ALERT SERVICE BULLETIN

SUBJECT: HYDRAULIC POWER SYSTEM - Plate Assembly

Installation of attachment hardware with double locking

Revision No.	Date of issue
Revision 0	2015-10-12
Revision 1	2016-10-14
Revision 2	2017-02-01
Revision 3	2017-12-19

Inspection and Check of the Hydraulic Module Plate Attachment Points
Figure 1

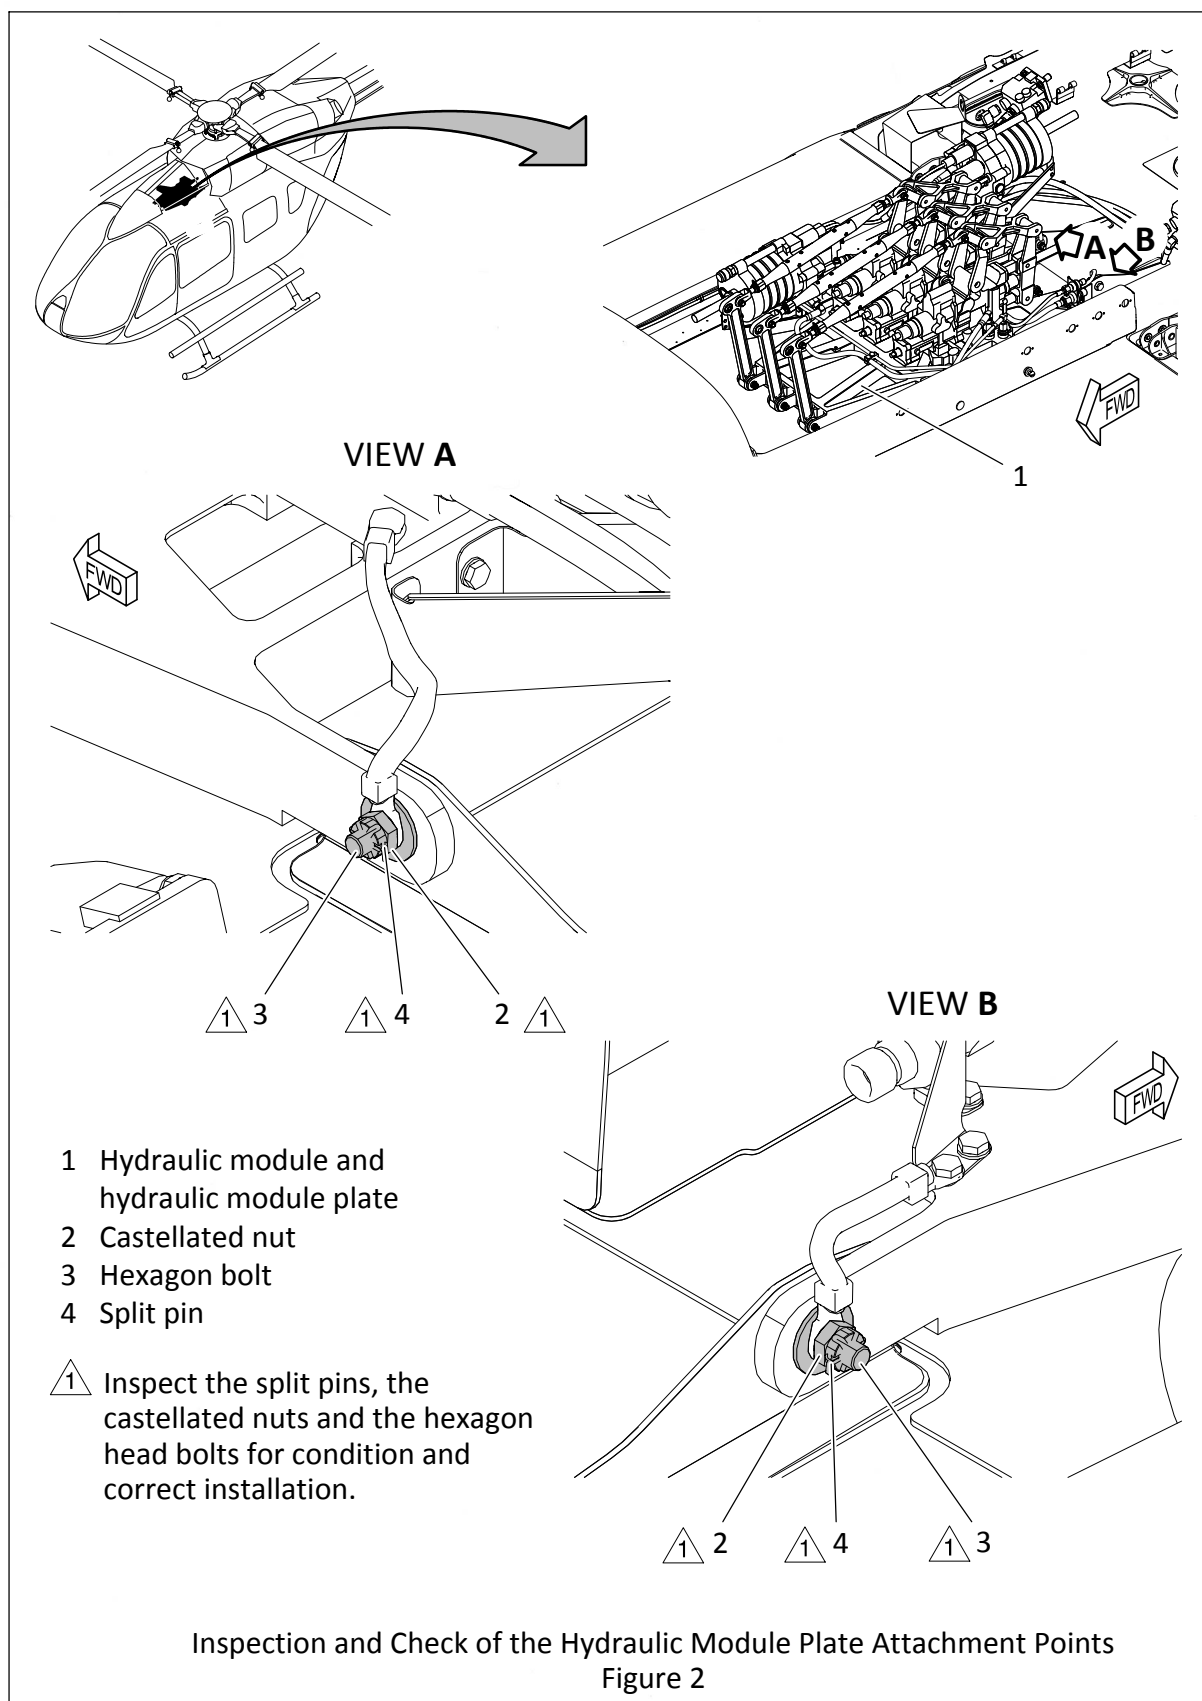
1. Remove the crest cowling i.a.w. AMM, 71-11-00, 4-1.
2. Remove LH and RH cover (4, Fig. 1).
3. Do a visual inspection of all four attachment points of the hydraulic module plate (1, Fig. 1 and Fig. 2) for condition:
 - a. Inspect the LH and RH split pins (4, Fig. 2) for condition and correct installation.
 - b. Inspect the LH and RH castellated nuts (2, Fig. 2) and the hexagon bolts (3) for condition and correct installation.
 - c. Inspect the LH and RH nuts (3, Fig. 1) for cracks in installed condition using a mirror and a flashlight.
 - d. Inspect the LH and RH hexagon bolts (2, Fig. 1) for condition in installed condition using a mirror and a flashlight.
 - e. If cracks are detected during the visual inspection, replace the affected parts before the next flight and inform AHD customer support.

1. Do a check of the tightening torque of the forward attachment points of the hydraulic module plate (1, Fig. 1):
 - a. Apply the required tightening torque of 9-10 Nm to the LH and RH nuts (3, Fig. 1) to check tight fit.
 - b. If the torque cannot be applied, replace the affected parts before the next flight and inform AHD customer support.

- ① Use a mirror and a flashlight to inspect the nut and the hexagon bolt for condition.
- ② Check the nut for tightening torque.

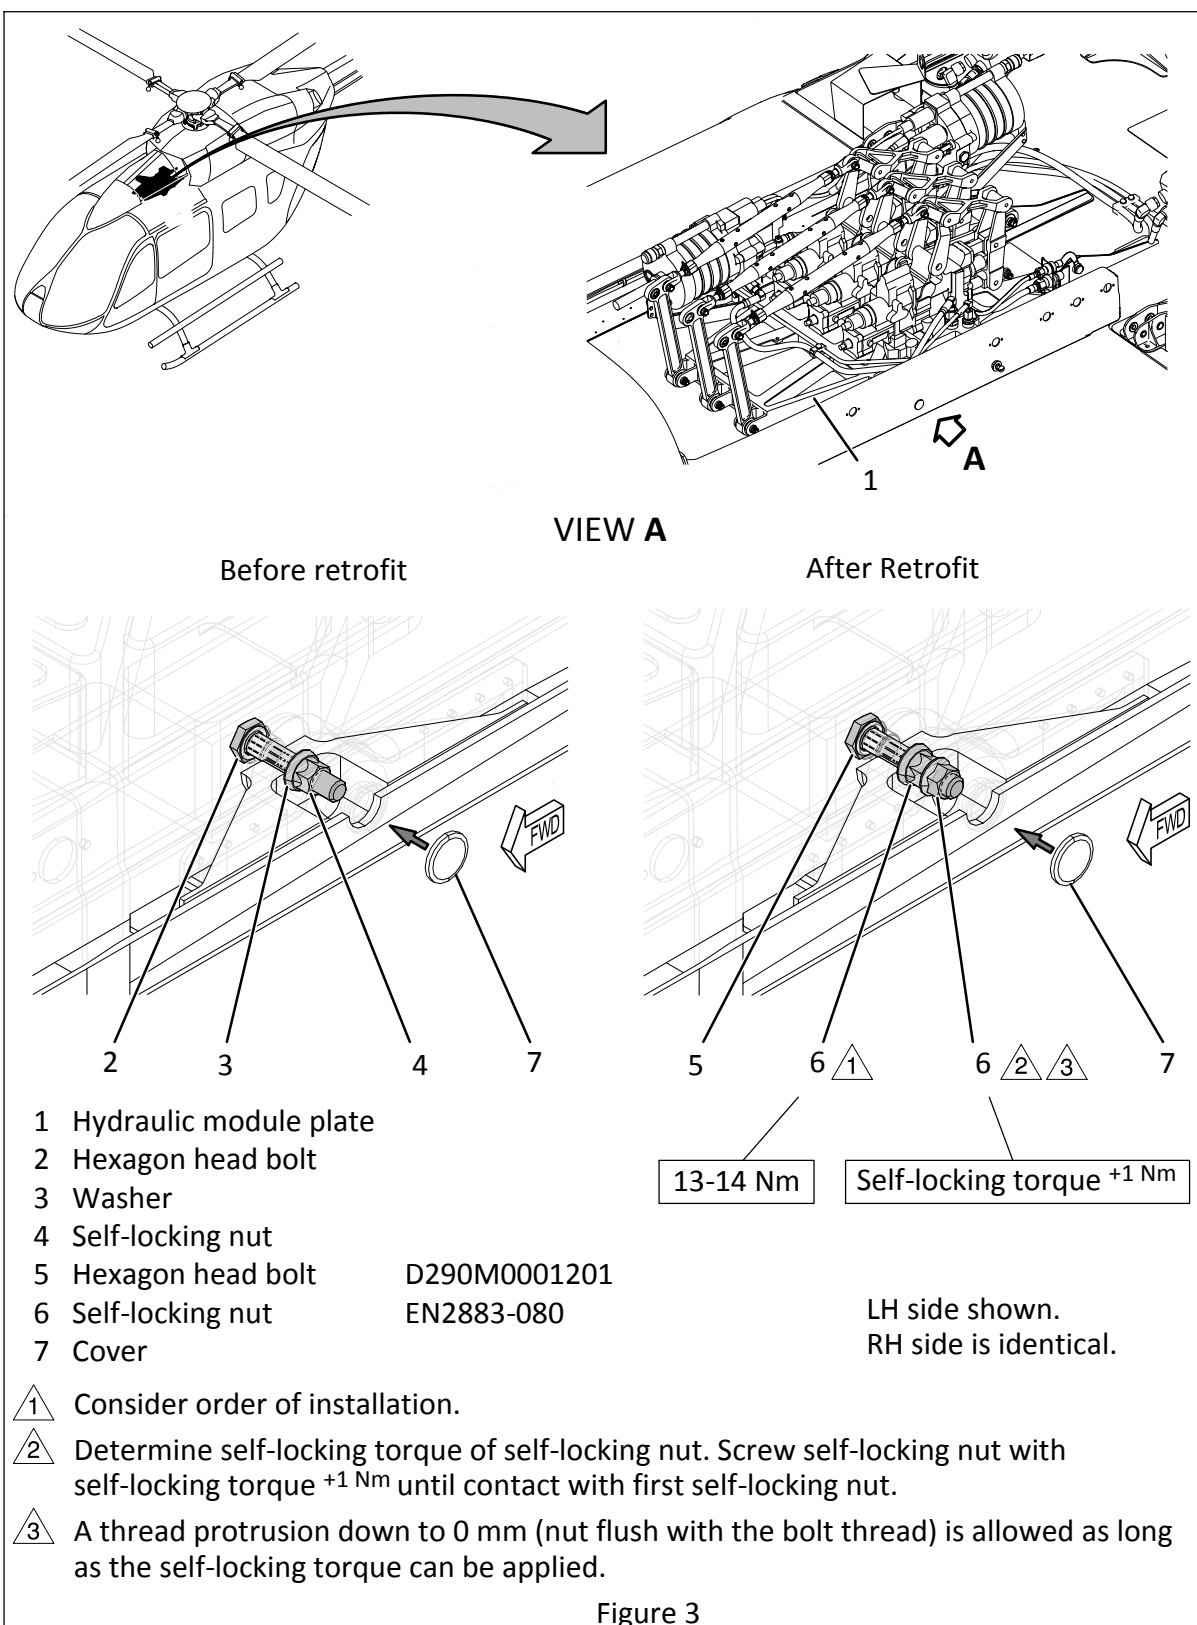
3.B.3 Retrofit of the attachment hardwareRetrofit of the forward attachment hardware:

1. Remove the crest cowling i.a.w. AMM, 71-11-00, 4-1.
2. Remove LH and RH cover (7, Fig. 3).

3. Remove the self-locking nut (4, Fig. 3), the washer (3) and the hexagon head bolt (2). Discard old parts.
4. Install the new hexagon head bolt (5, Fig. 3) and the new self-locking nut (6). Tighten the self-locking-nut (6) with a tightening torque of 13-14 Nm.
5. Determine the self-locking torque of the self-locking nut (6, Fig. 3):

- a. Screw the self-locking nut (6, Fig. 3) on the hexagon bolt (5).
- b. Determine self-locking torque:
 - Adjust a torque wrench initially to 1.0 Nm.
 - Increase the adjustment of the torque wrench until the self-locking nut (6, Fig. 3) can be screwed without a click sound of the torque wrench.

NOTE A thread protrusion down to 0 mm (nut flush with the bolt thread) is allowed as long as the self-locking torque can be applied.

6. Screw the second self-locking nut (6, Fig. 3) with the determined self-locking torque $+1 \text{ Nm}$ until it has contact with the first self-locking nut.

Figure 4

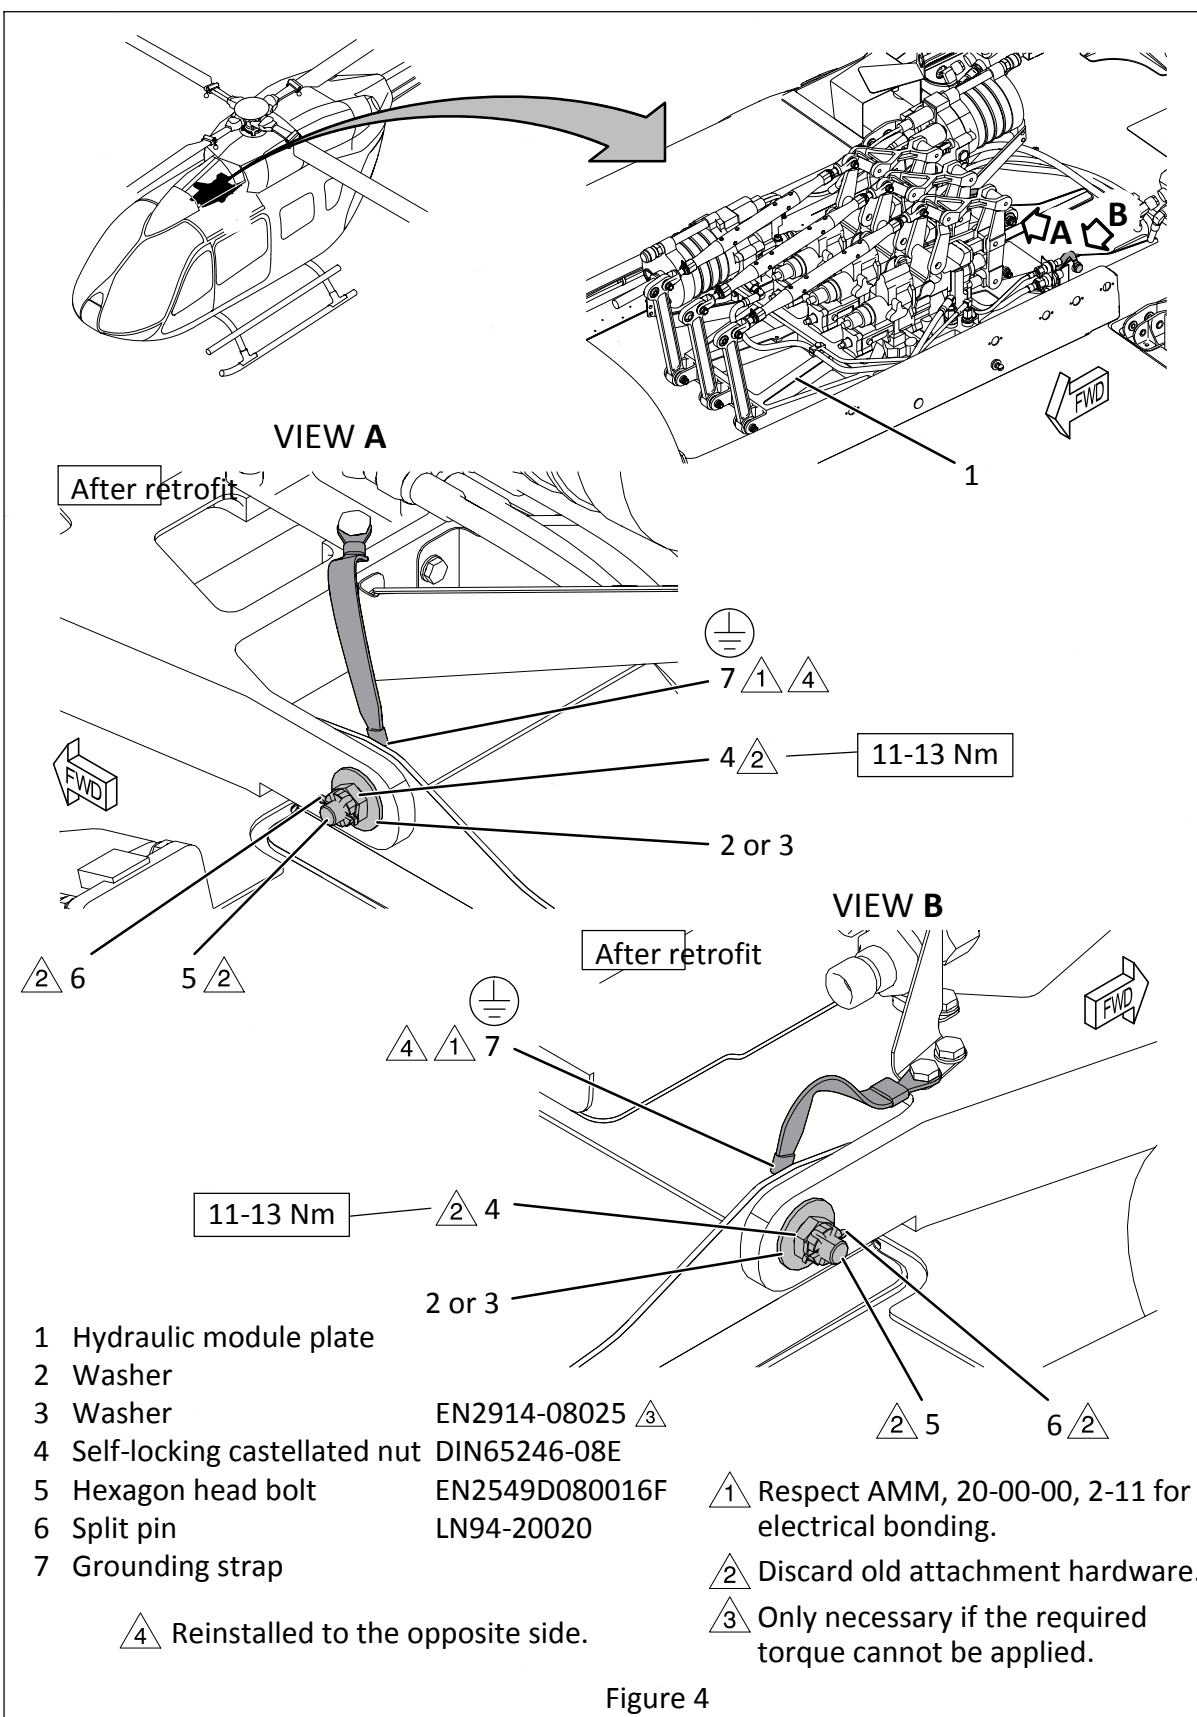
Retrofit of the aft attachment hardware:

1. Remove the installed split pin (6, Fig. 4), the castellated nut (4), the grounding strap (7), the washer (2) and the hexagon head bolt (5).
2. Store the washer (2, Fig. 4) for reuse. Discard the split pin (6), the castellated nut (4) and the hexagon head bolt (5).

NOTE During the reinstallation the grounding strap must be installed to the opposite site of the attachment point of the hydraulic module plate (see Figure 4).

3. Install the new hexagon head bolt (5, Fig. 4), the washer (2), the grounding strap (7) and the new self-locking castellated nut (4). Tighten the self-locking castellated nut (4) with a tightening torque of 11-13 Nm.
4. Check the clamping effect of the LH and RH screw joints :
 - a. Set a torque wrench to 8 Nm and tighten both screw joints to the tightening direction without using a counter torque.
 - b. If the screw joints **cannot** be turned proceed with Step 5.
 - c. If a screw joint **can** be turned:

NOTE The washers (3, Fig. 4) are not included in material kit SB-117C2-29A-003-2C and must be ordered separately with material kit SB-117C2-29A-003-2C2 if necessary.

NOTE If one screw joint is affected it is recommended to replace the washer (2, Fig. 4) on the LH and RH aft screw joint of the hydraulic module plate.

- Remove both self-locking castellated nuts (4, Fig. 4).
- Replace both washers (2, Fig. 4) with washers (3).

NOTE A low thread protrusion is allowed while using the washer (3, Fig. 4). The thread end of the screw **must** be at least flush with the top of the nut. If the thread end of the screw **is not** at least flush with the top of the nut on the **not affected** screw joint, the washer (2) must be reinstalled.

- Install both self-locking castellated nuts (4, Fig. 4). Tighten both self-locking castellated nut (4) with a tightening torque of 11-13 Nm.
5. Secure both self-locking castellated nut (4, Fig. 4) with a new split pins (6).
 6. Check the electrical bonding of the hydraulic module i.a.w. AMM, 20-00-00, 2-11.
 7. Protect the grounding connection with PU-Lacquer (CM 478, CM 479, CM 480).

Figure 5

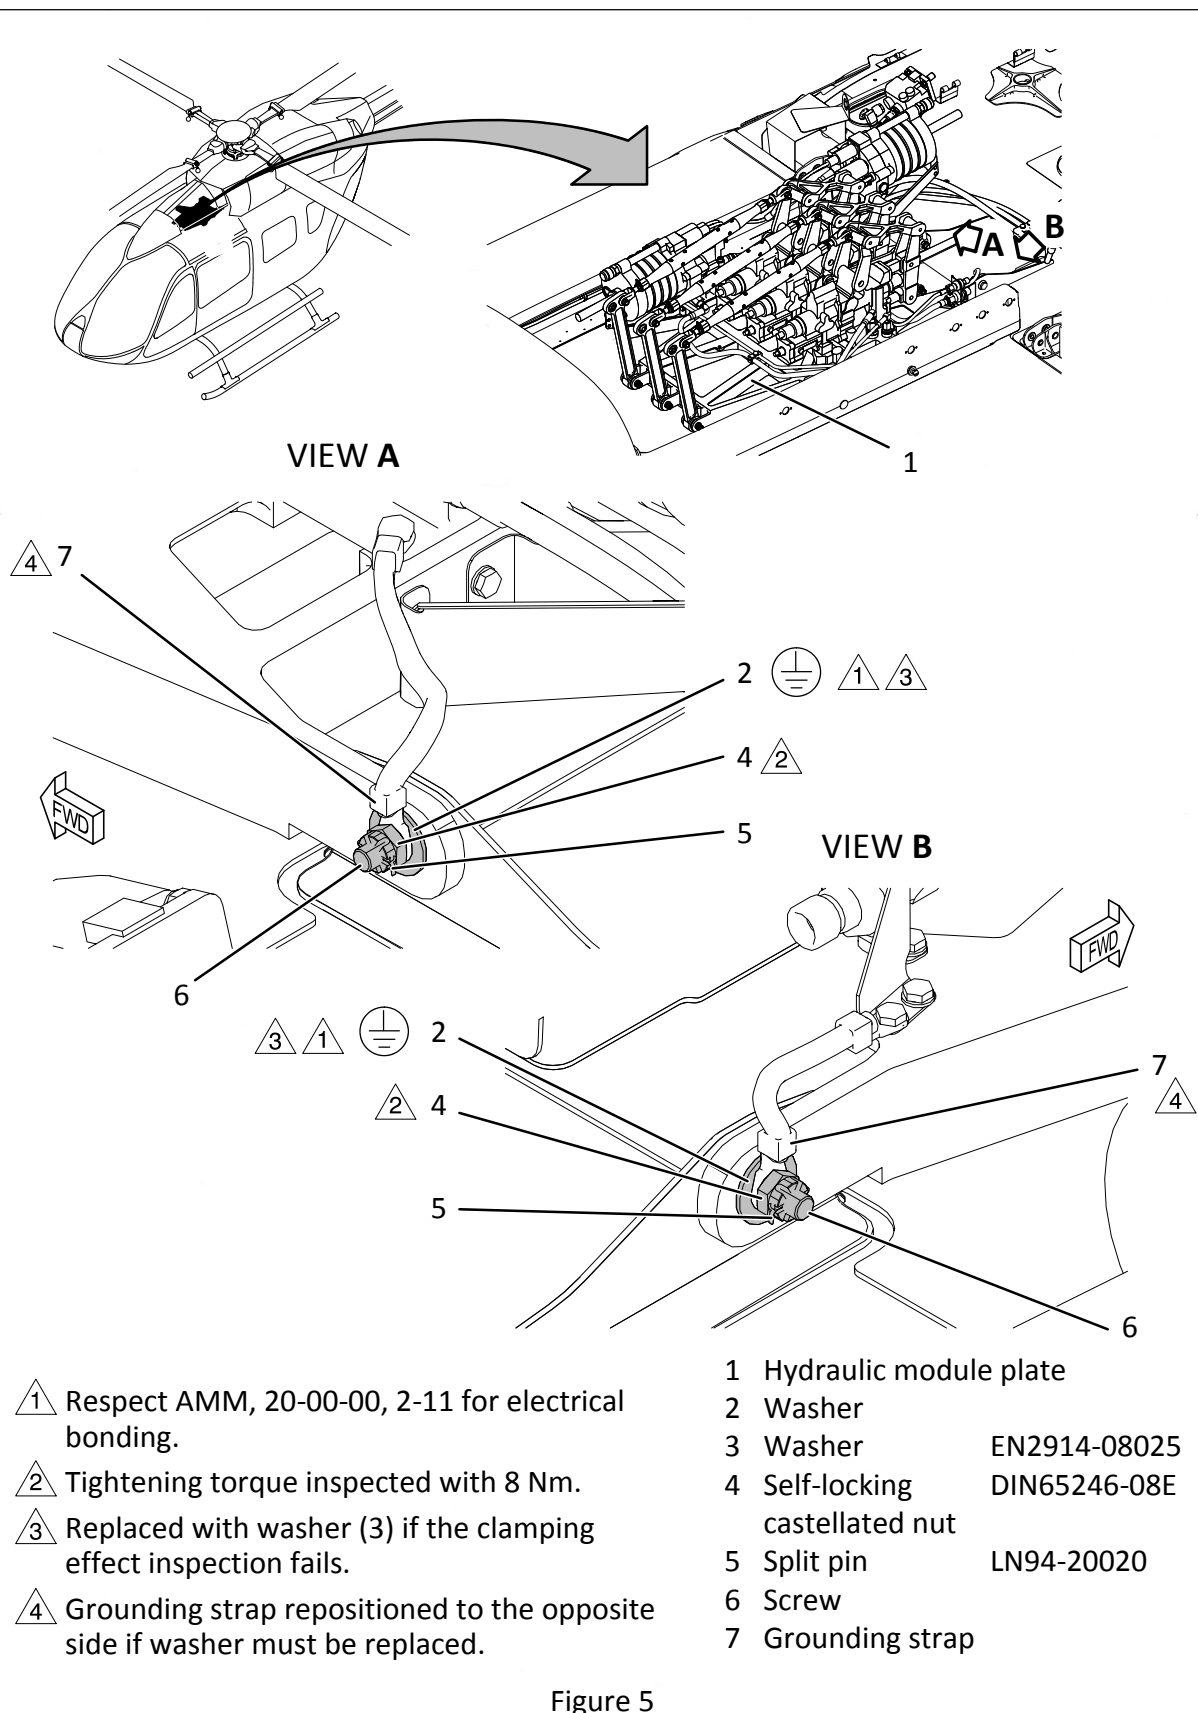
1. Remove the crest cowling i.a.w. AMM, 71-11-00, 4-1.
2. Do an inspection of the clamping effect of the LH and RH aft screw joints of the hydraulic module plate (1, Fig. 5):
 - a. Set a torque wrench to 8 Nm and tighten both screw joints to the tightening direction without using a counter torque.
 - b. If both screw joints cannot be turned proceed with Step 3.
 - c. If a screw joint can be turned:

NOTE The washers (3, Fig. 5) are not included in material kit SB-117C2-29A-003-2C and must be ordered separately with material kit SB-117C2-29A-003-2C2 if necessary.

NOTE If one screw joint is affected it is recommended to replace the washer (2, Fig. 5) on the LH and RH aft screw joint of the hydraulic module plate.

- Remove both split pins (5, Fig. 5). Discard the split pin.
- Remove both self-locking castellated nuts (4, Fig. 5). Discard the self-locking castellated nut
- Check the affected screw (6, Fig. 5) for wear and replace the screw if necessary.
- Reposition the grounding strap (7, Fig. 5) to the opposite site of the attachment point of the hydraulic module plate (see Figure 4).
- Replace both washers (2, Fig. 5) with washers (3).

NOTE A low thread protrusion is allowed while using the washer (3, Fig. 5). The thread end of the screw **must** be at least flush with the top of the nut. If the thread end of the screw **is not** at least flush with the top of the nut on the **not affected** screw joint, washer (2) must be reinstalled.

- Install the new self-locking castellated nut (4, Fig. 5). Tighten the self-locking castellated nut (4) with a tightening torque of 11-13 Nm.
- Check the electrical bonding i.a.w. AMM, 20-00-00, 2-11.
- Secure the self-locking castellated nut (4, Fig. 5) with a new split pin (5).
- Protect the grounding connection with PU-Lacquer (CM 478, CM 479, CM 480).
